Wimblehurst Road Residents Association

Date: 19 May 2025

Ref: Outline Planning Application DC/25/0629, Former Novartis Site, Parsonage Road, Horsham RH12 5AA.

Stance of response for Outline Planning Application DC/25/0629: Object

Fig.5 Possible road sign position in Parsonage Road

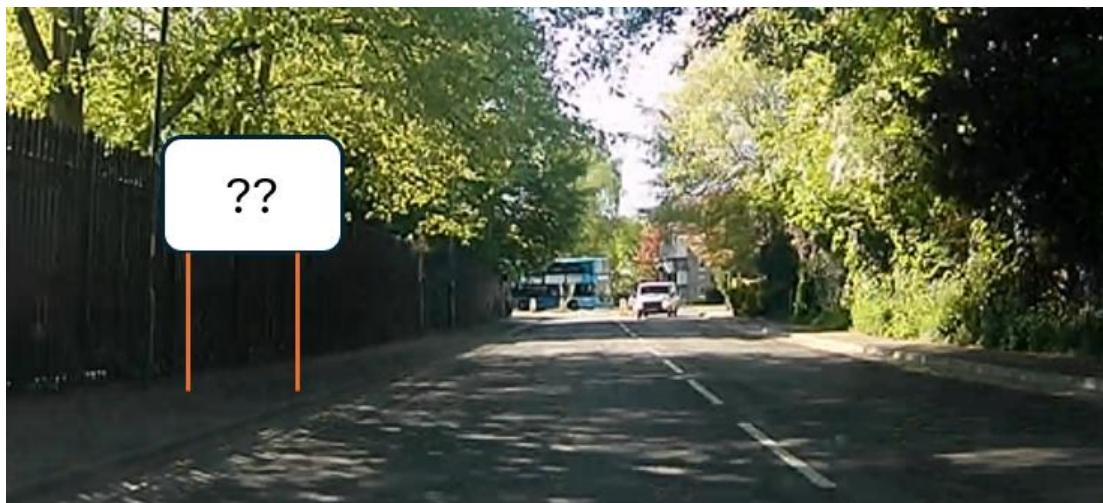
2.5.4 The second factor is how the junction is going to be presented to a driver approaching the junction along Parsonage Road, especially those with no local knowledge. Unambiguous information on the immediate potential dangers as drivers prepare to bear left at the junction will be an essential element in reducing the risk of collisions and injury.

Fig. 6 Junction schematic from Appendix I

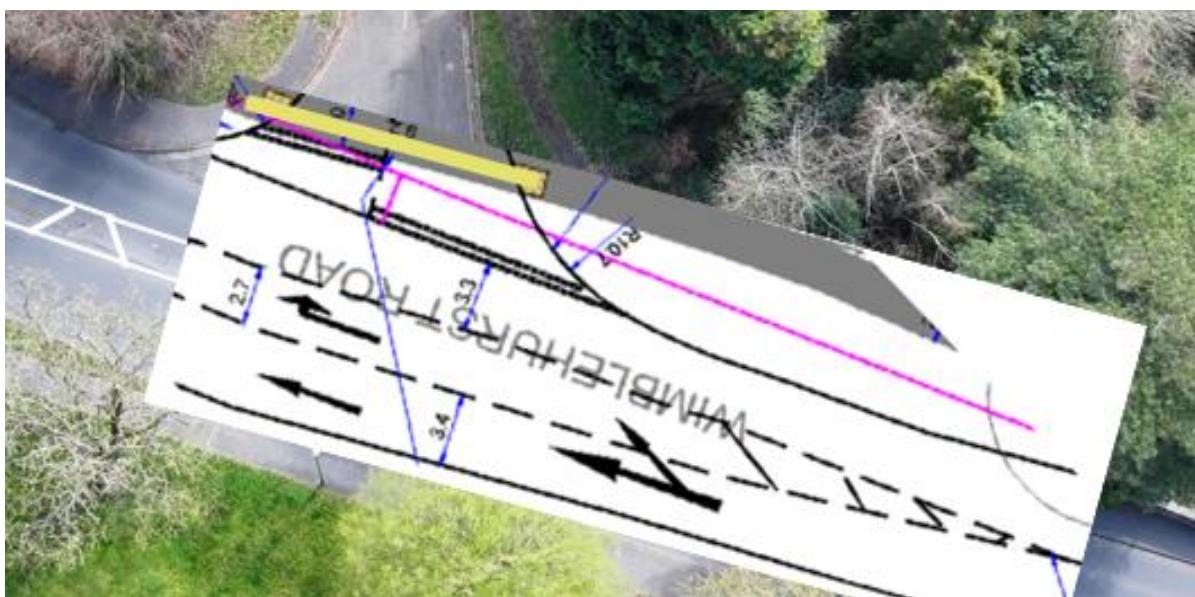
2.5.6 In Fig 6 the scale drawing in Appendix I has been overlaid on a photograph of the junction.

2.5.7 The schematic only shows the initial path from the ghost lane into the Wimblehurst gate. There are no arrows representing traffic approaching from the mini-roundabout or from traffic exiting the site. The reality is much more complex and potentially dangerous.

2.5.8 No comment is made on potential obstructions to traffic travelling southbound. The relevant schematic of the ghost lane is shown in Fig. 5. Although the schematic has arrows for the northbound traffic there are none for the southbound traffic. The fact that there is traffic approaching from the mini-roundabout and out of the development is therefore not obvious. No reason is given as to why only traffic in a northbound direction is presented.

2.5.15 The overview of traffic paths and conflicts in Fig. 6 above omits the need to accommodate cyclists in Wimblehurst Road, which the developers state is a priority to deliver. In Fig. 9 below the cycle paths are shown in a dark blue dotted line. Going towards the mini-roundabout they may be squeezed for space by vehicles (especially buses and commercial traffic) that have to move over close to the kerb in order to give clearance to the ghost lane.

Fig.7 Traffic path analysis photomontage

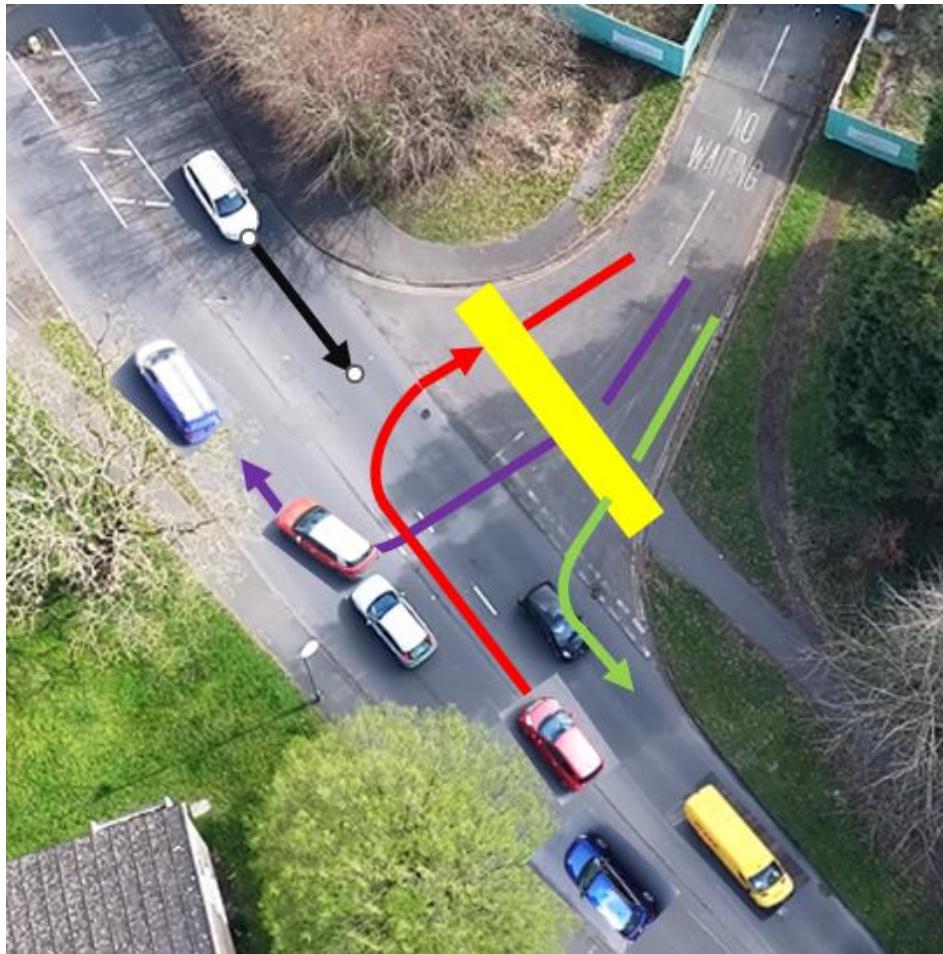
2.5.9 In Fig.7 on the next page a photomontage is presented which indicates the complex array of vehicle movements around the face of the bell mouth access.

- 2.5.9 The red car is in the ghost lane, planning to turn right into the entrance. However, the driver will have to give way to pedestrians on the Copenhagen crossing (yellow stripe). The white car approaching from the roundabout will not be able to see if there are pedestrians on the crossing and anticipate that the red car may not immediately be able to move off the road. It will not be clear to either of the two drivers who has precedence.

- 2.5.10 The driver of red car with a white roof needs to turn right (46% of exits will do so) and it has to find a slot in traffic approaching the mini-roundabout. Their vision of the oncoming traffic may be partially or totally obscured by the red car in the ghost lane.

- 2.5.11 The situation is made more challenging because as drivers approach the railway bridge the incline of Wimblehurst Road over the railway bridge obscures the traffic disposition at this junction. Although not the responsibility of the developers it is

Fig. 9 Cycle paths (dotted blue) in Wimblehurst Road

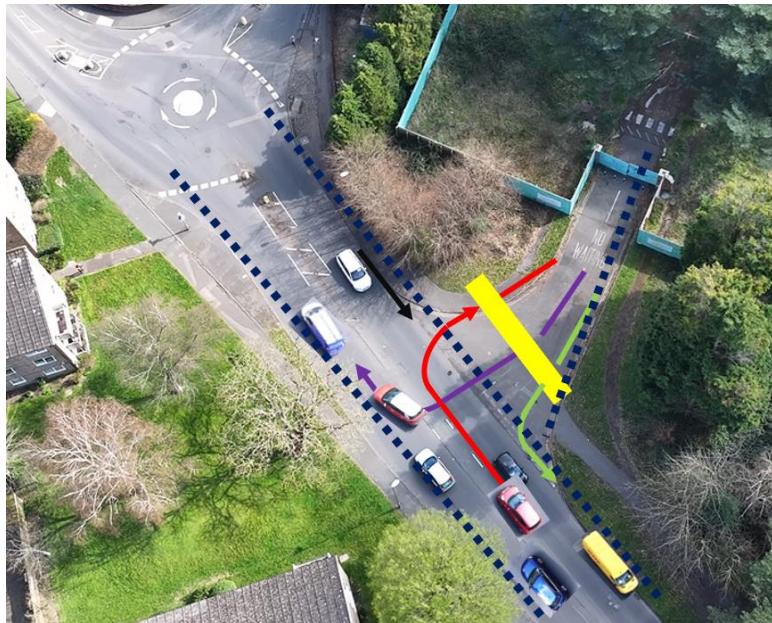
2.5.16 Cycling away from the mini-roundabout cyclists have traffic approaching them (out of vision) from both Parsonage Road and North Heath Lane and as they approach

the Wimblehurst Road access they are faced with traffic moving across in both directions.

Fig. 18 Proposed pedestrian crossing at Richmond Road

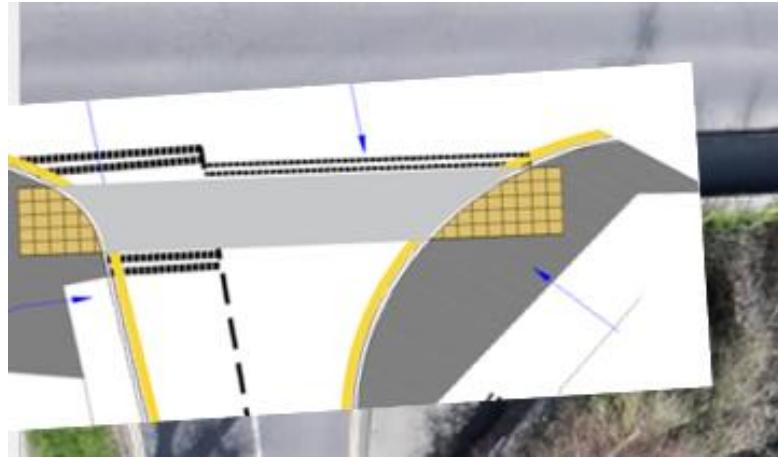
2.5.28 The Application proposes that a pedestrian priority traverse is installed at this junction. The design is shown below in which the schematic from Appendix I has been overlaid on a drone photograph.

2.5.29 This is not a solution to the safety of pedestrians. The vast majority of pedestrians walking over the railway bridge towards the Richmond Road junction are planning to walk down Richmond Road itself. There is no reason for them to walk on down Wimblehurst Road other than to access one of the houses.

Fig. 19 Pedestrian route across Richmond Road.

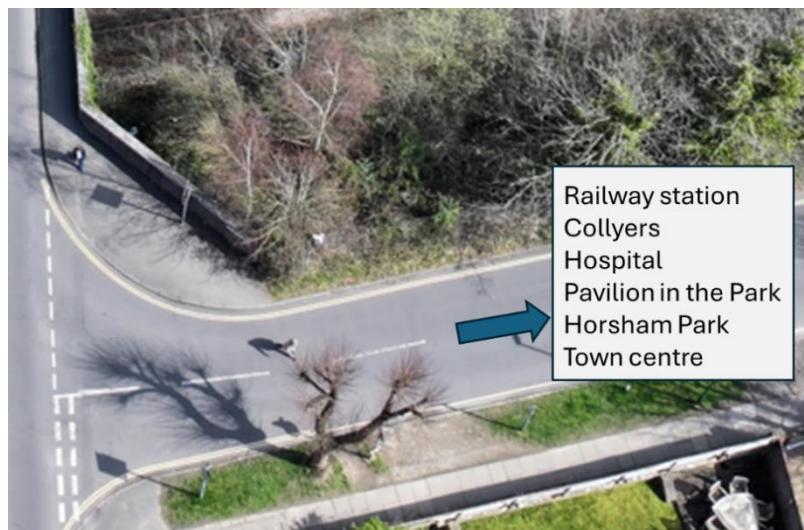
2.5.30 These pedestrians take a short cut across the road to the opposite side as there is no pavement on the northern kerb. A pedestrian can be seen in Fig. 19.

2.5.31 If there are one or more cars waiting to exit into Wimblehurst Road in either direction a pedestrian can see traffic slowly approaching and walk behind the stationary car with a high degree of safety. There are of course cars coming around the corner from the railway bridge but the corner is very tight and that gives just enough extra time to be aware of pedestrians crossing the road at an angle.

Fig. 1 Aerial view of the Boulevard

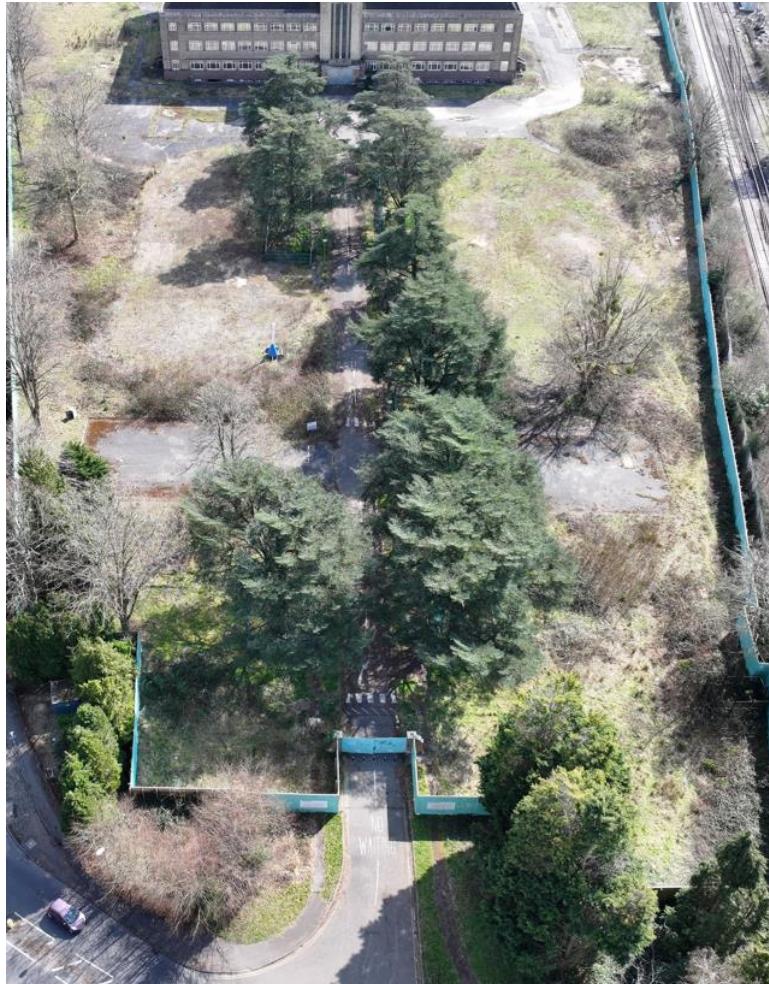
4.1 Tree conservation – objection to the application to ‘replace’ the existing Atlas cedar trees
